GM SERVICE AND PARTS OPERATIONS  
DCS1297  
URGENT DISTRIBUTE IMMEDIATELY

Subject: 04087 / Product Safety Recall  
Tail Lamps/Stop Lamps

Models: 2004 Buick Rainier  
2002-2004 Chevrolet TrailBlazer, TrailBlazer EXT  
2002-2004 GMC Envoy, Envoy XL  
2002-2004 Oldsmobile Bravada

## PRODUCT SAFETY RECALL

732917

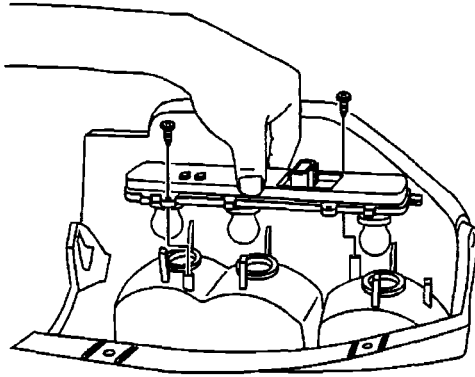
3. Inspect the part number on both the left and right tail lamp circuit boards.

- o If the part number printed on a circuit board IS one of the part numbers listed above, then the circuit board is the new design and does NOT need to be replaced.
- o If the part number printed on a circuit board is NOT one of the part numbers listed above, then the circuit board is the old design and **MUST BE REPLACED**. Proceed to the next step if either circuit board needs to be replaced.

4. Turn on the tail lamps, directional signals, etc. and determine if there are any bulbs that require replacement.
5. Disconnect the electrical connector from the circuit board being replaced.

6. Remove the three screws attaching the circuit board to the tail lamp and remove the circuit board.
7. Install a NEW stop lamp bulb in a NEW circuit board.
  - o On Chevrolet, Buick, and Oldsmobile vehicles, the stop lamp bulb is located in the UPPER (top) socket in the circuit board.
  - o On GMC vehicles, the stop lamp bulb is located in the LOWER (bottom) socket in the circuit board.
